BRAIDEN ACOUSTICS LTD

NOISE VERIFICATION REPORT

Site : 302 Platt Lane, Fallowfield

Report No. : 11256revB

Figure 1
Plan drawing showing the ducted exhaust system

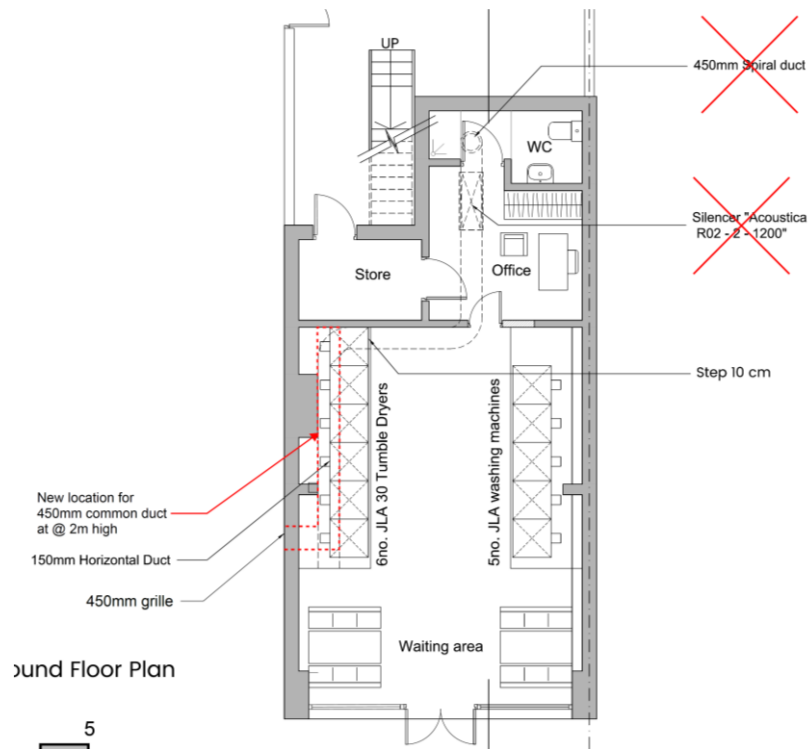
Be advised - The extraction scheme fitted is not the same as the one approved in figure 3 of the Braiden acoustics report no 11065revA dated 4 September 2023 relied on for the approval of Condition 5a) under condition discharge reference CDN/23/0603. As such the installed scheme does not comply with that condition discharge approval.

- The original ventilation scheme could not be realised due to a structural beam; therefore, an updated Noise impact Assessment was undertaken, dated 13 Dec 2023, report number 11065revC.
- Noise measurements were undertaken one meter from the grille due to relatively high levels of Background Noise. Even at this distance, the noise measurements would include reflections of nearby surfaces.
- The octave band calculation needs to be analysed to determine where the attenuation comes from. The noise character from the grille was mostly mid and high frequencies and the nearest habitable window has no direct line of sight whatsoever. In fact, there is a barrier path length difference of, at least, 0.6m; therefore a significant barrier effect.

¹ Due to on-site issues, the design has been changed so that the common extract duct now vents via a 450mm grille in the gable wall.
